5440 WADE PARK BLVD, SUITE 102 WWW.BGEINC.COM NC LICENSE #C-4397 ©2023	DESIGNED BY:				
	DRAWN BY:				
	REVIEWED BY:		DF		
			DF/JWM	10/02/2023	PER TOWN OF ROLESVILLE COMMENT
				08/01/2023	PER TOWN OF ROLESVILLE COMMENT
		REV	06/01/2023	INITIAL SUBMITTAL

PARKER RIDGE
82 SCHOOL STREET
ROLESVILLE / NORTH CAROLINA / 27571

CARVED STREET CT PLAN
AND PROFILE

**ZANNING DR PLAN AND
PROFILE**

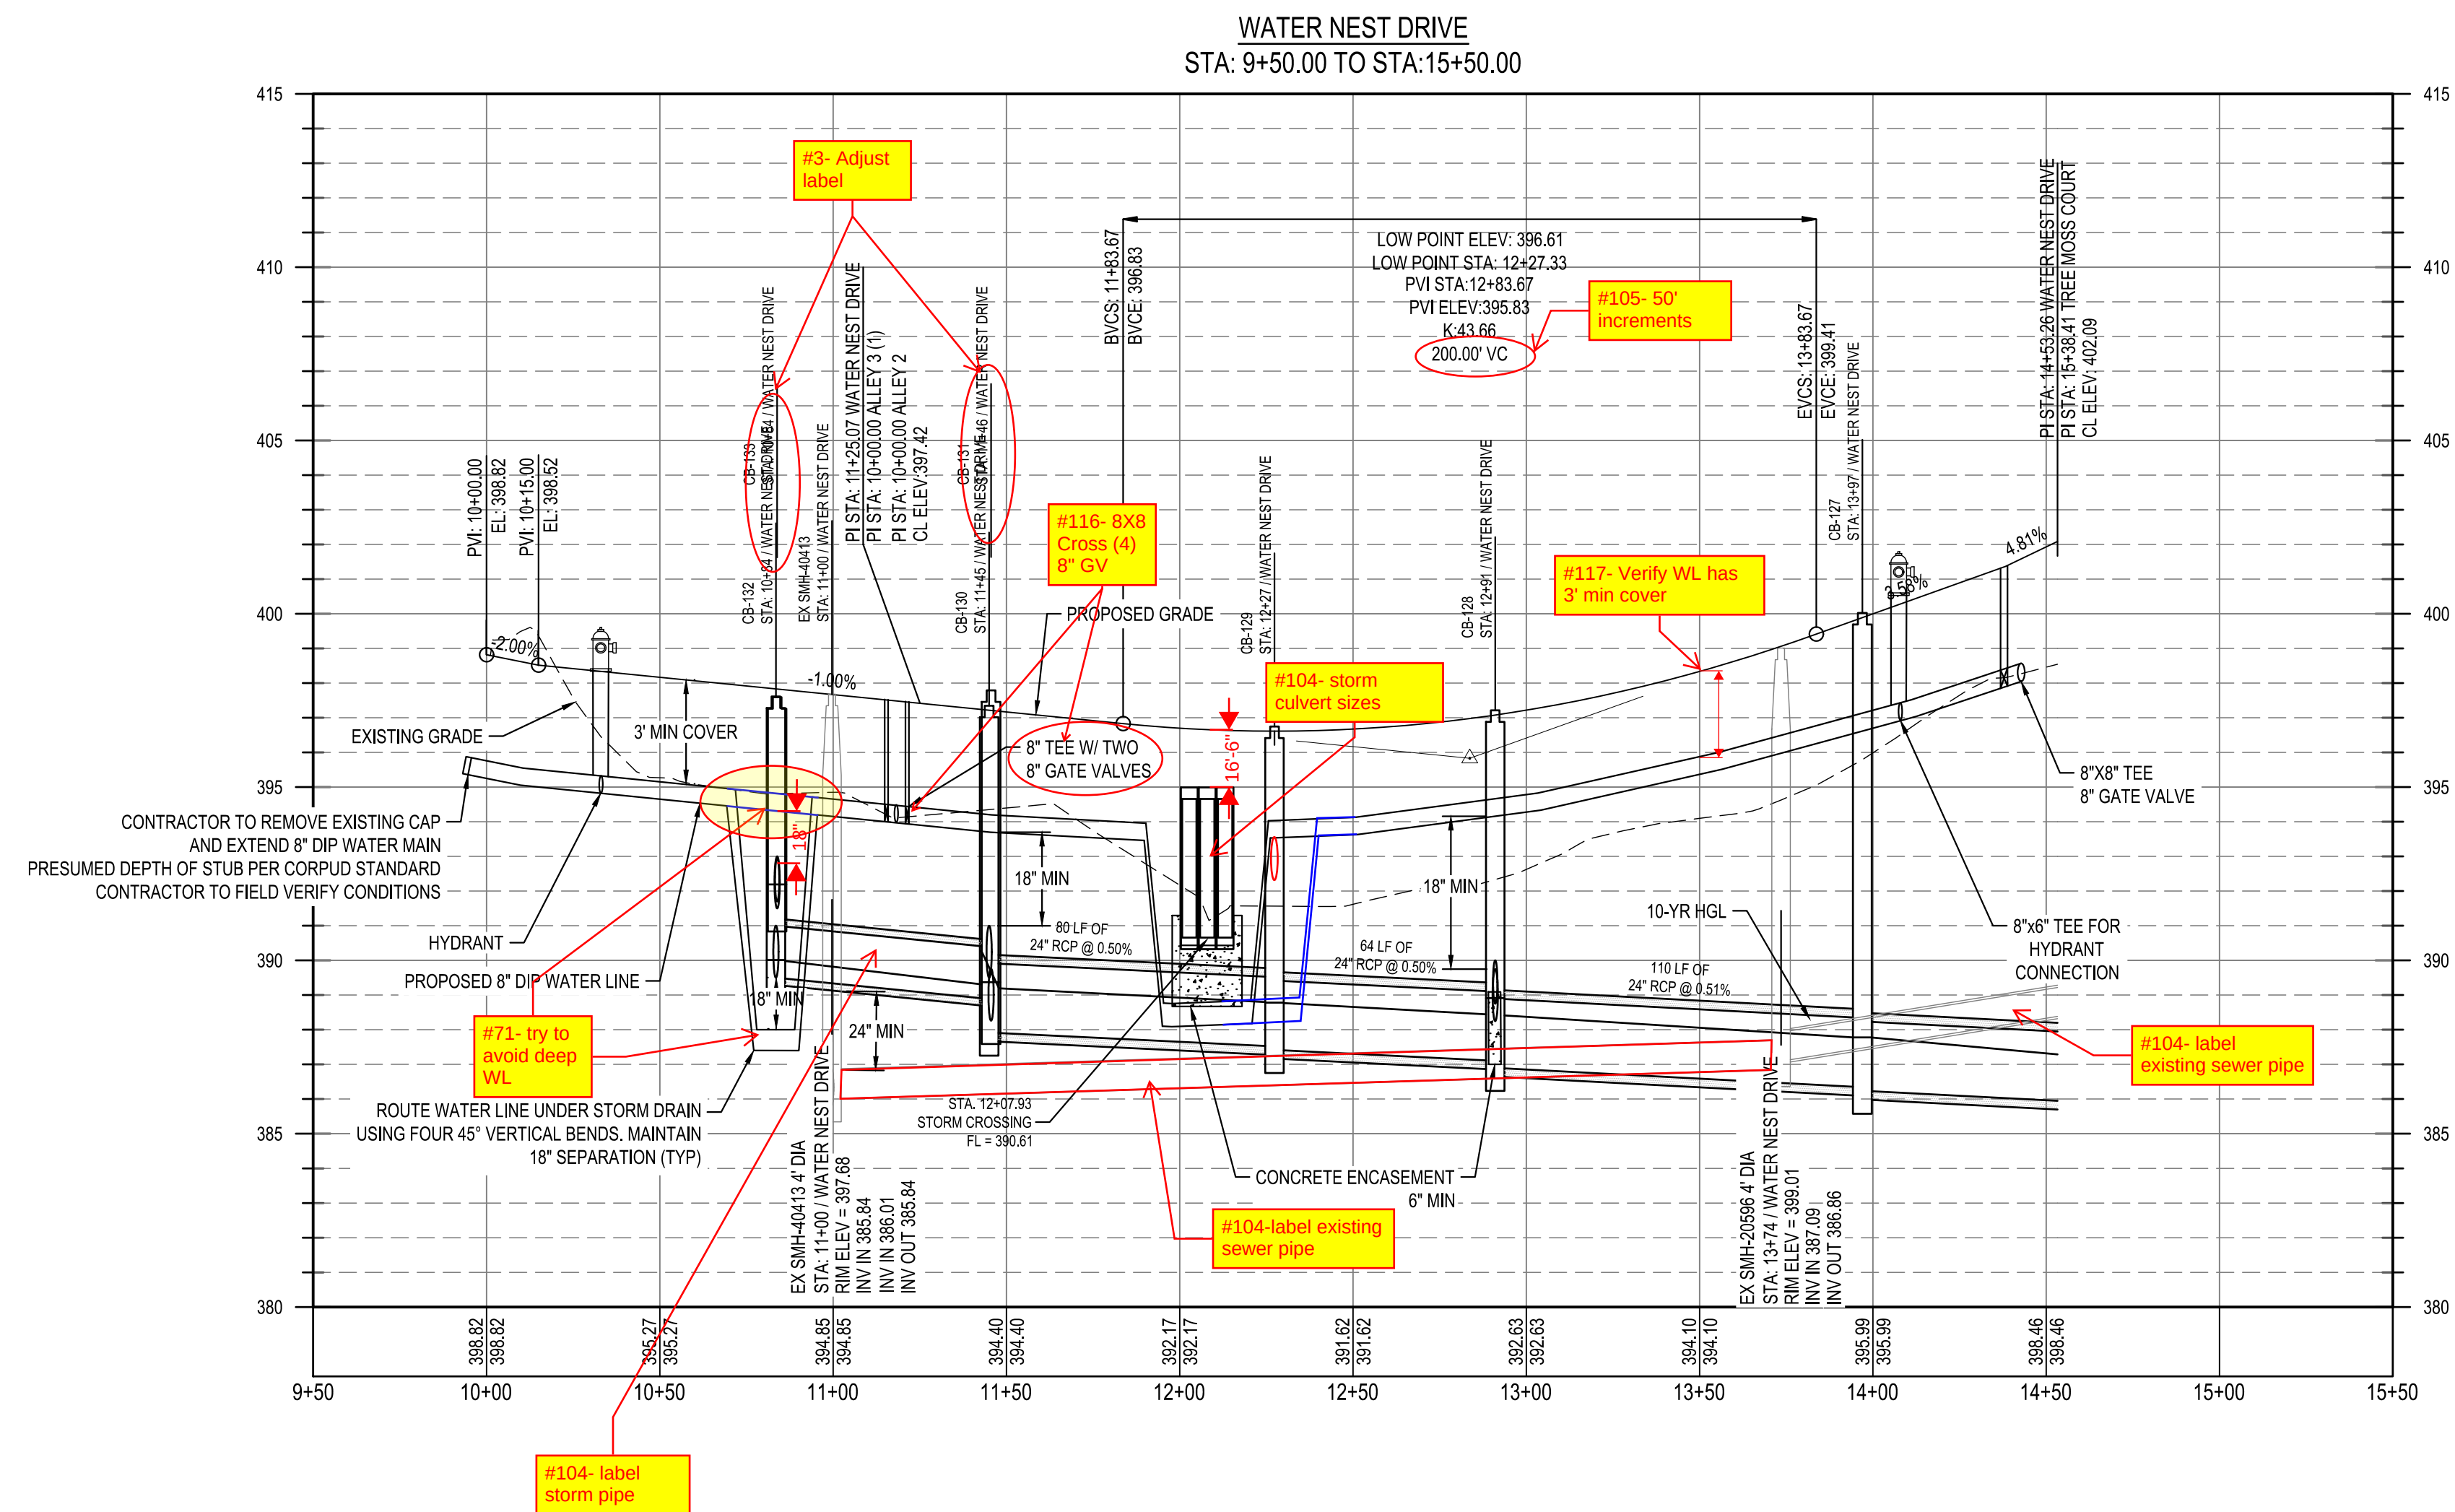
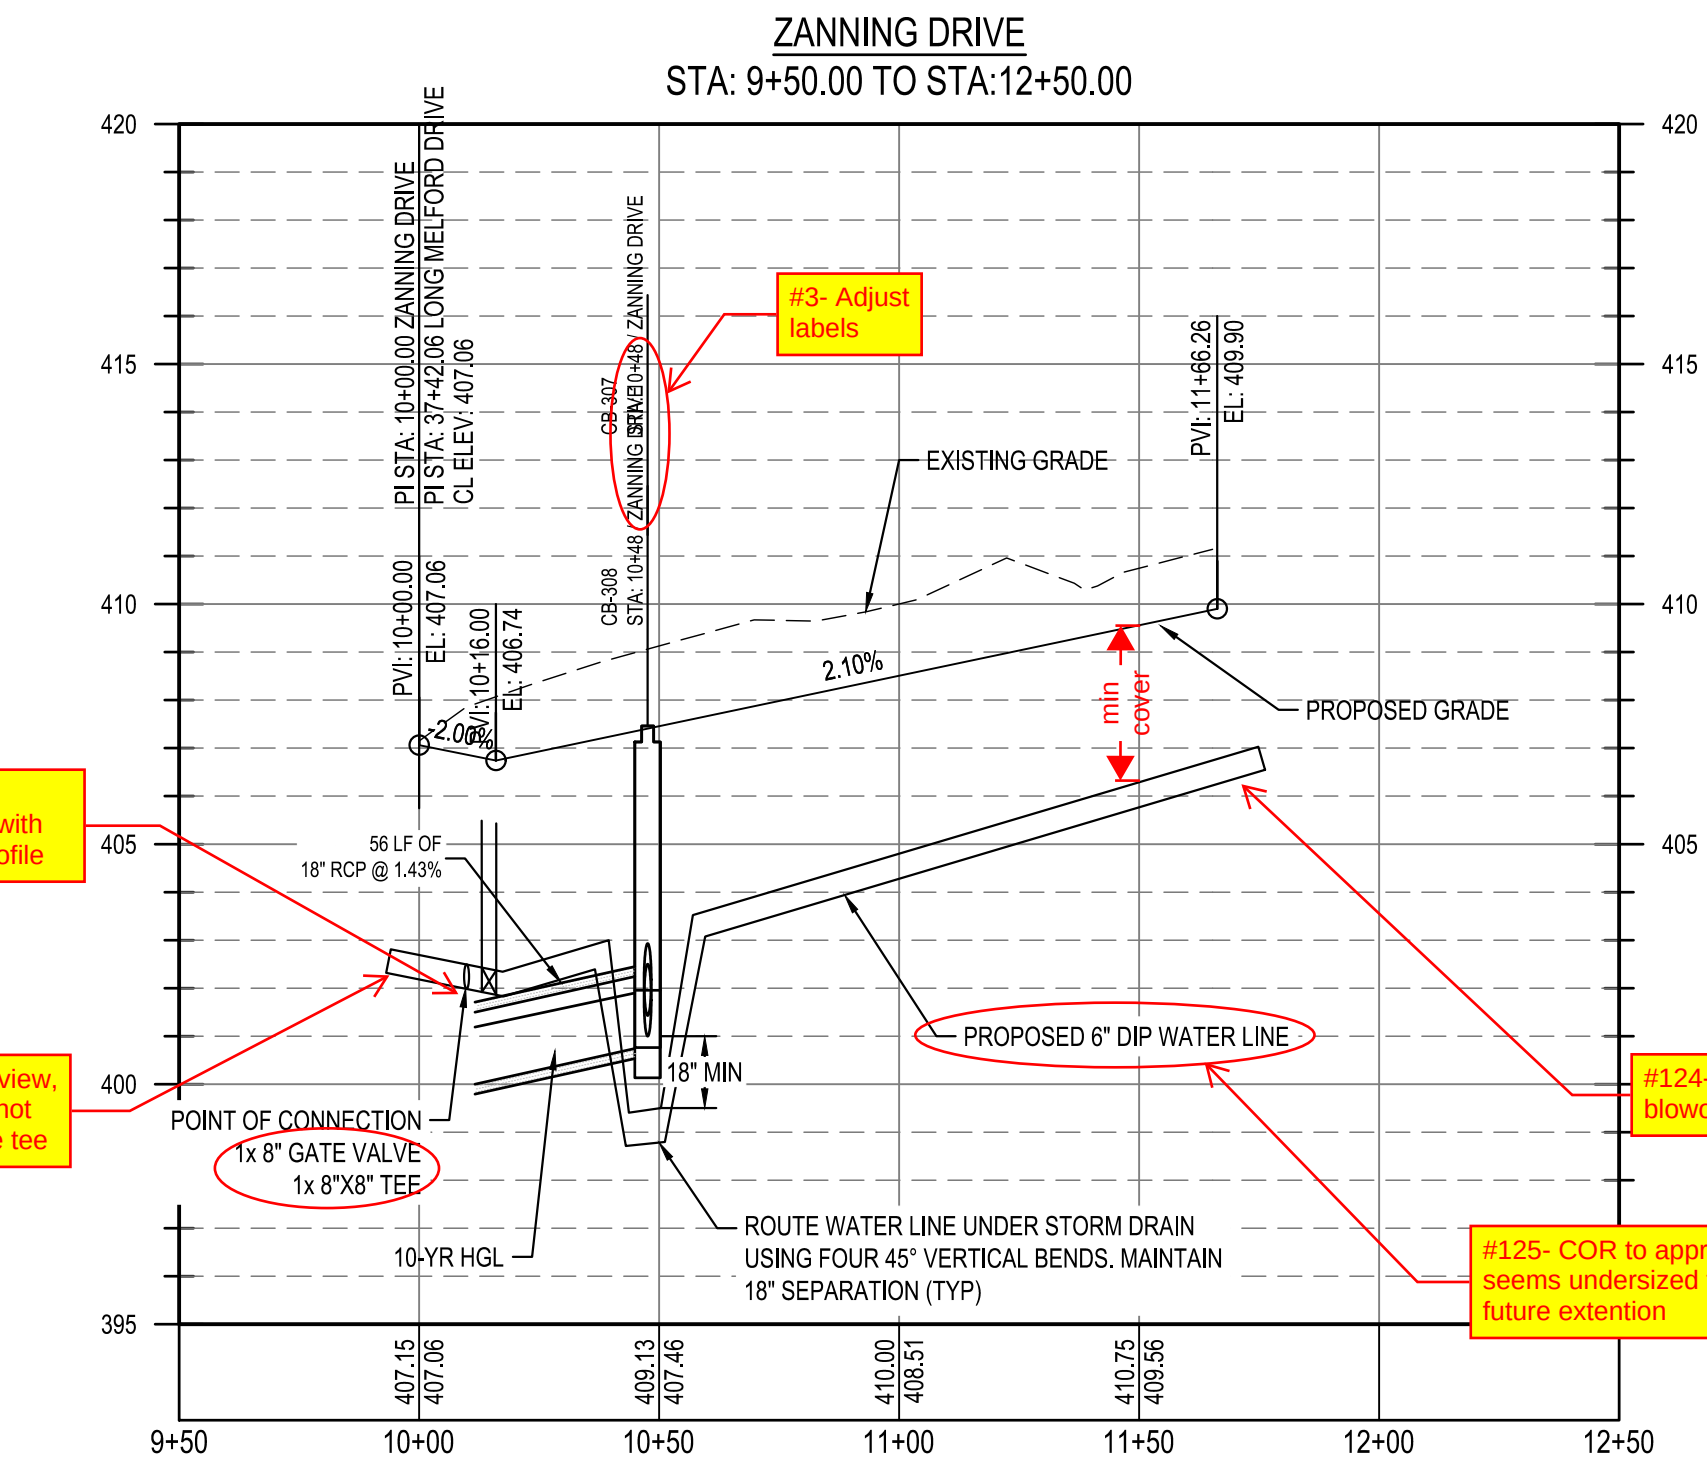
#102- Make sure dimensions are in the correct locations and it is clear what is being dimensions. Some dimensions don't seem to line up with top/bottom of pipes. If crossings do not meet minimum requirements, the design will need to be adjusted. Minimum separation requirements should be shown at all pipe crossings. This comment applies to all profile sheets.

#23- There are several instances where water line, tees/crosses, and valve sizes differ between Utility plan sheets and Plan and Profile sheets. Please make the necessary adjustments to ensure that water lines, connections, and valves correct sizes remain consistent throughout all sheets.

Sheet C3-1 shows 12" tee (3) 12" GV
Profile labels 8"x8" tee which is correct?

#104- label Reducer

#126- waterline to property line

#127- proposed sewer?
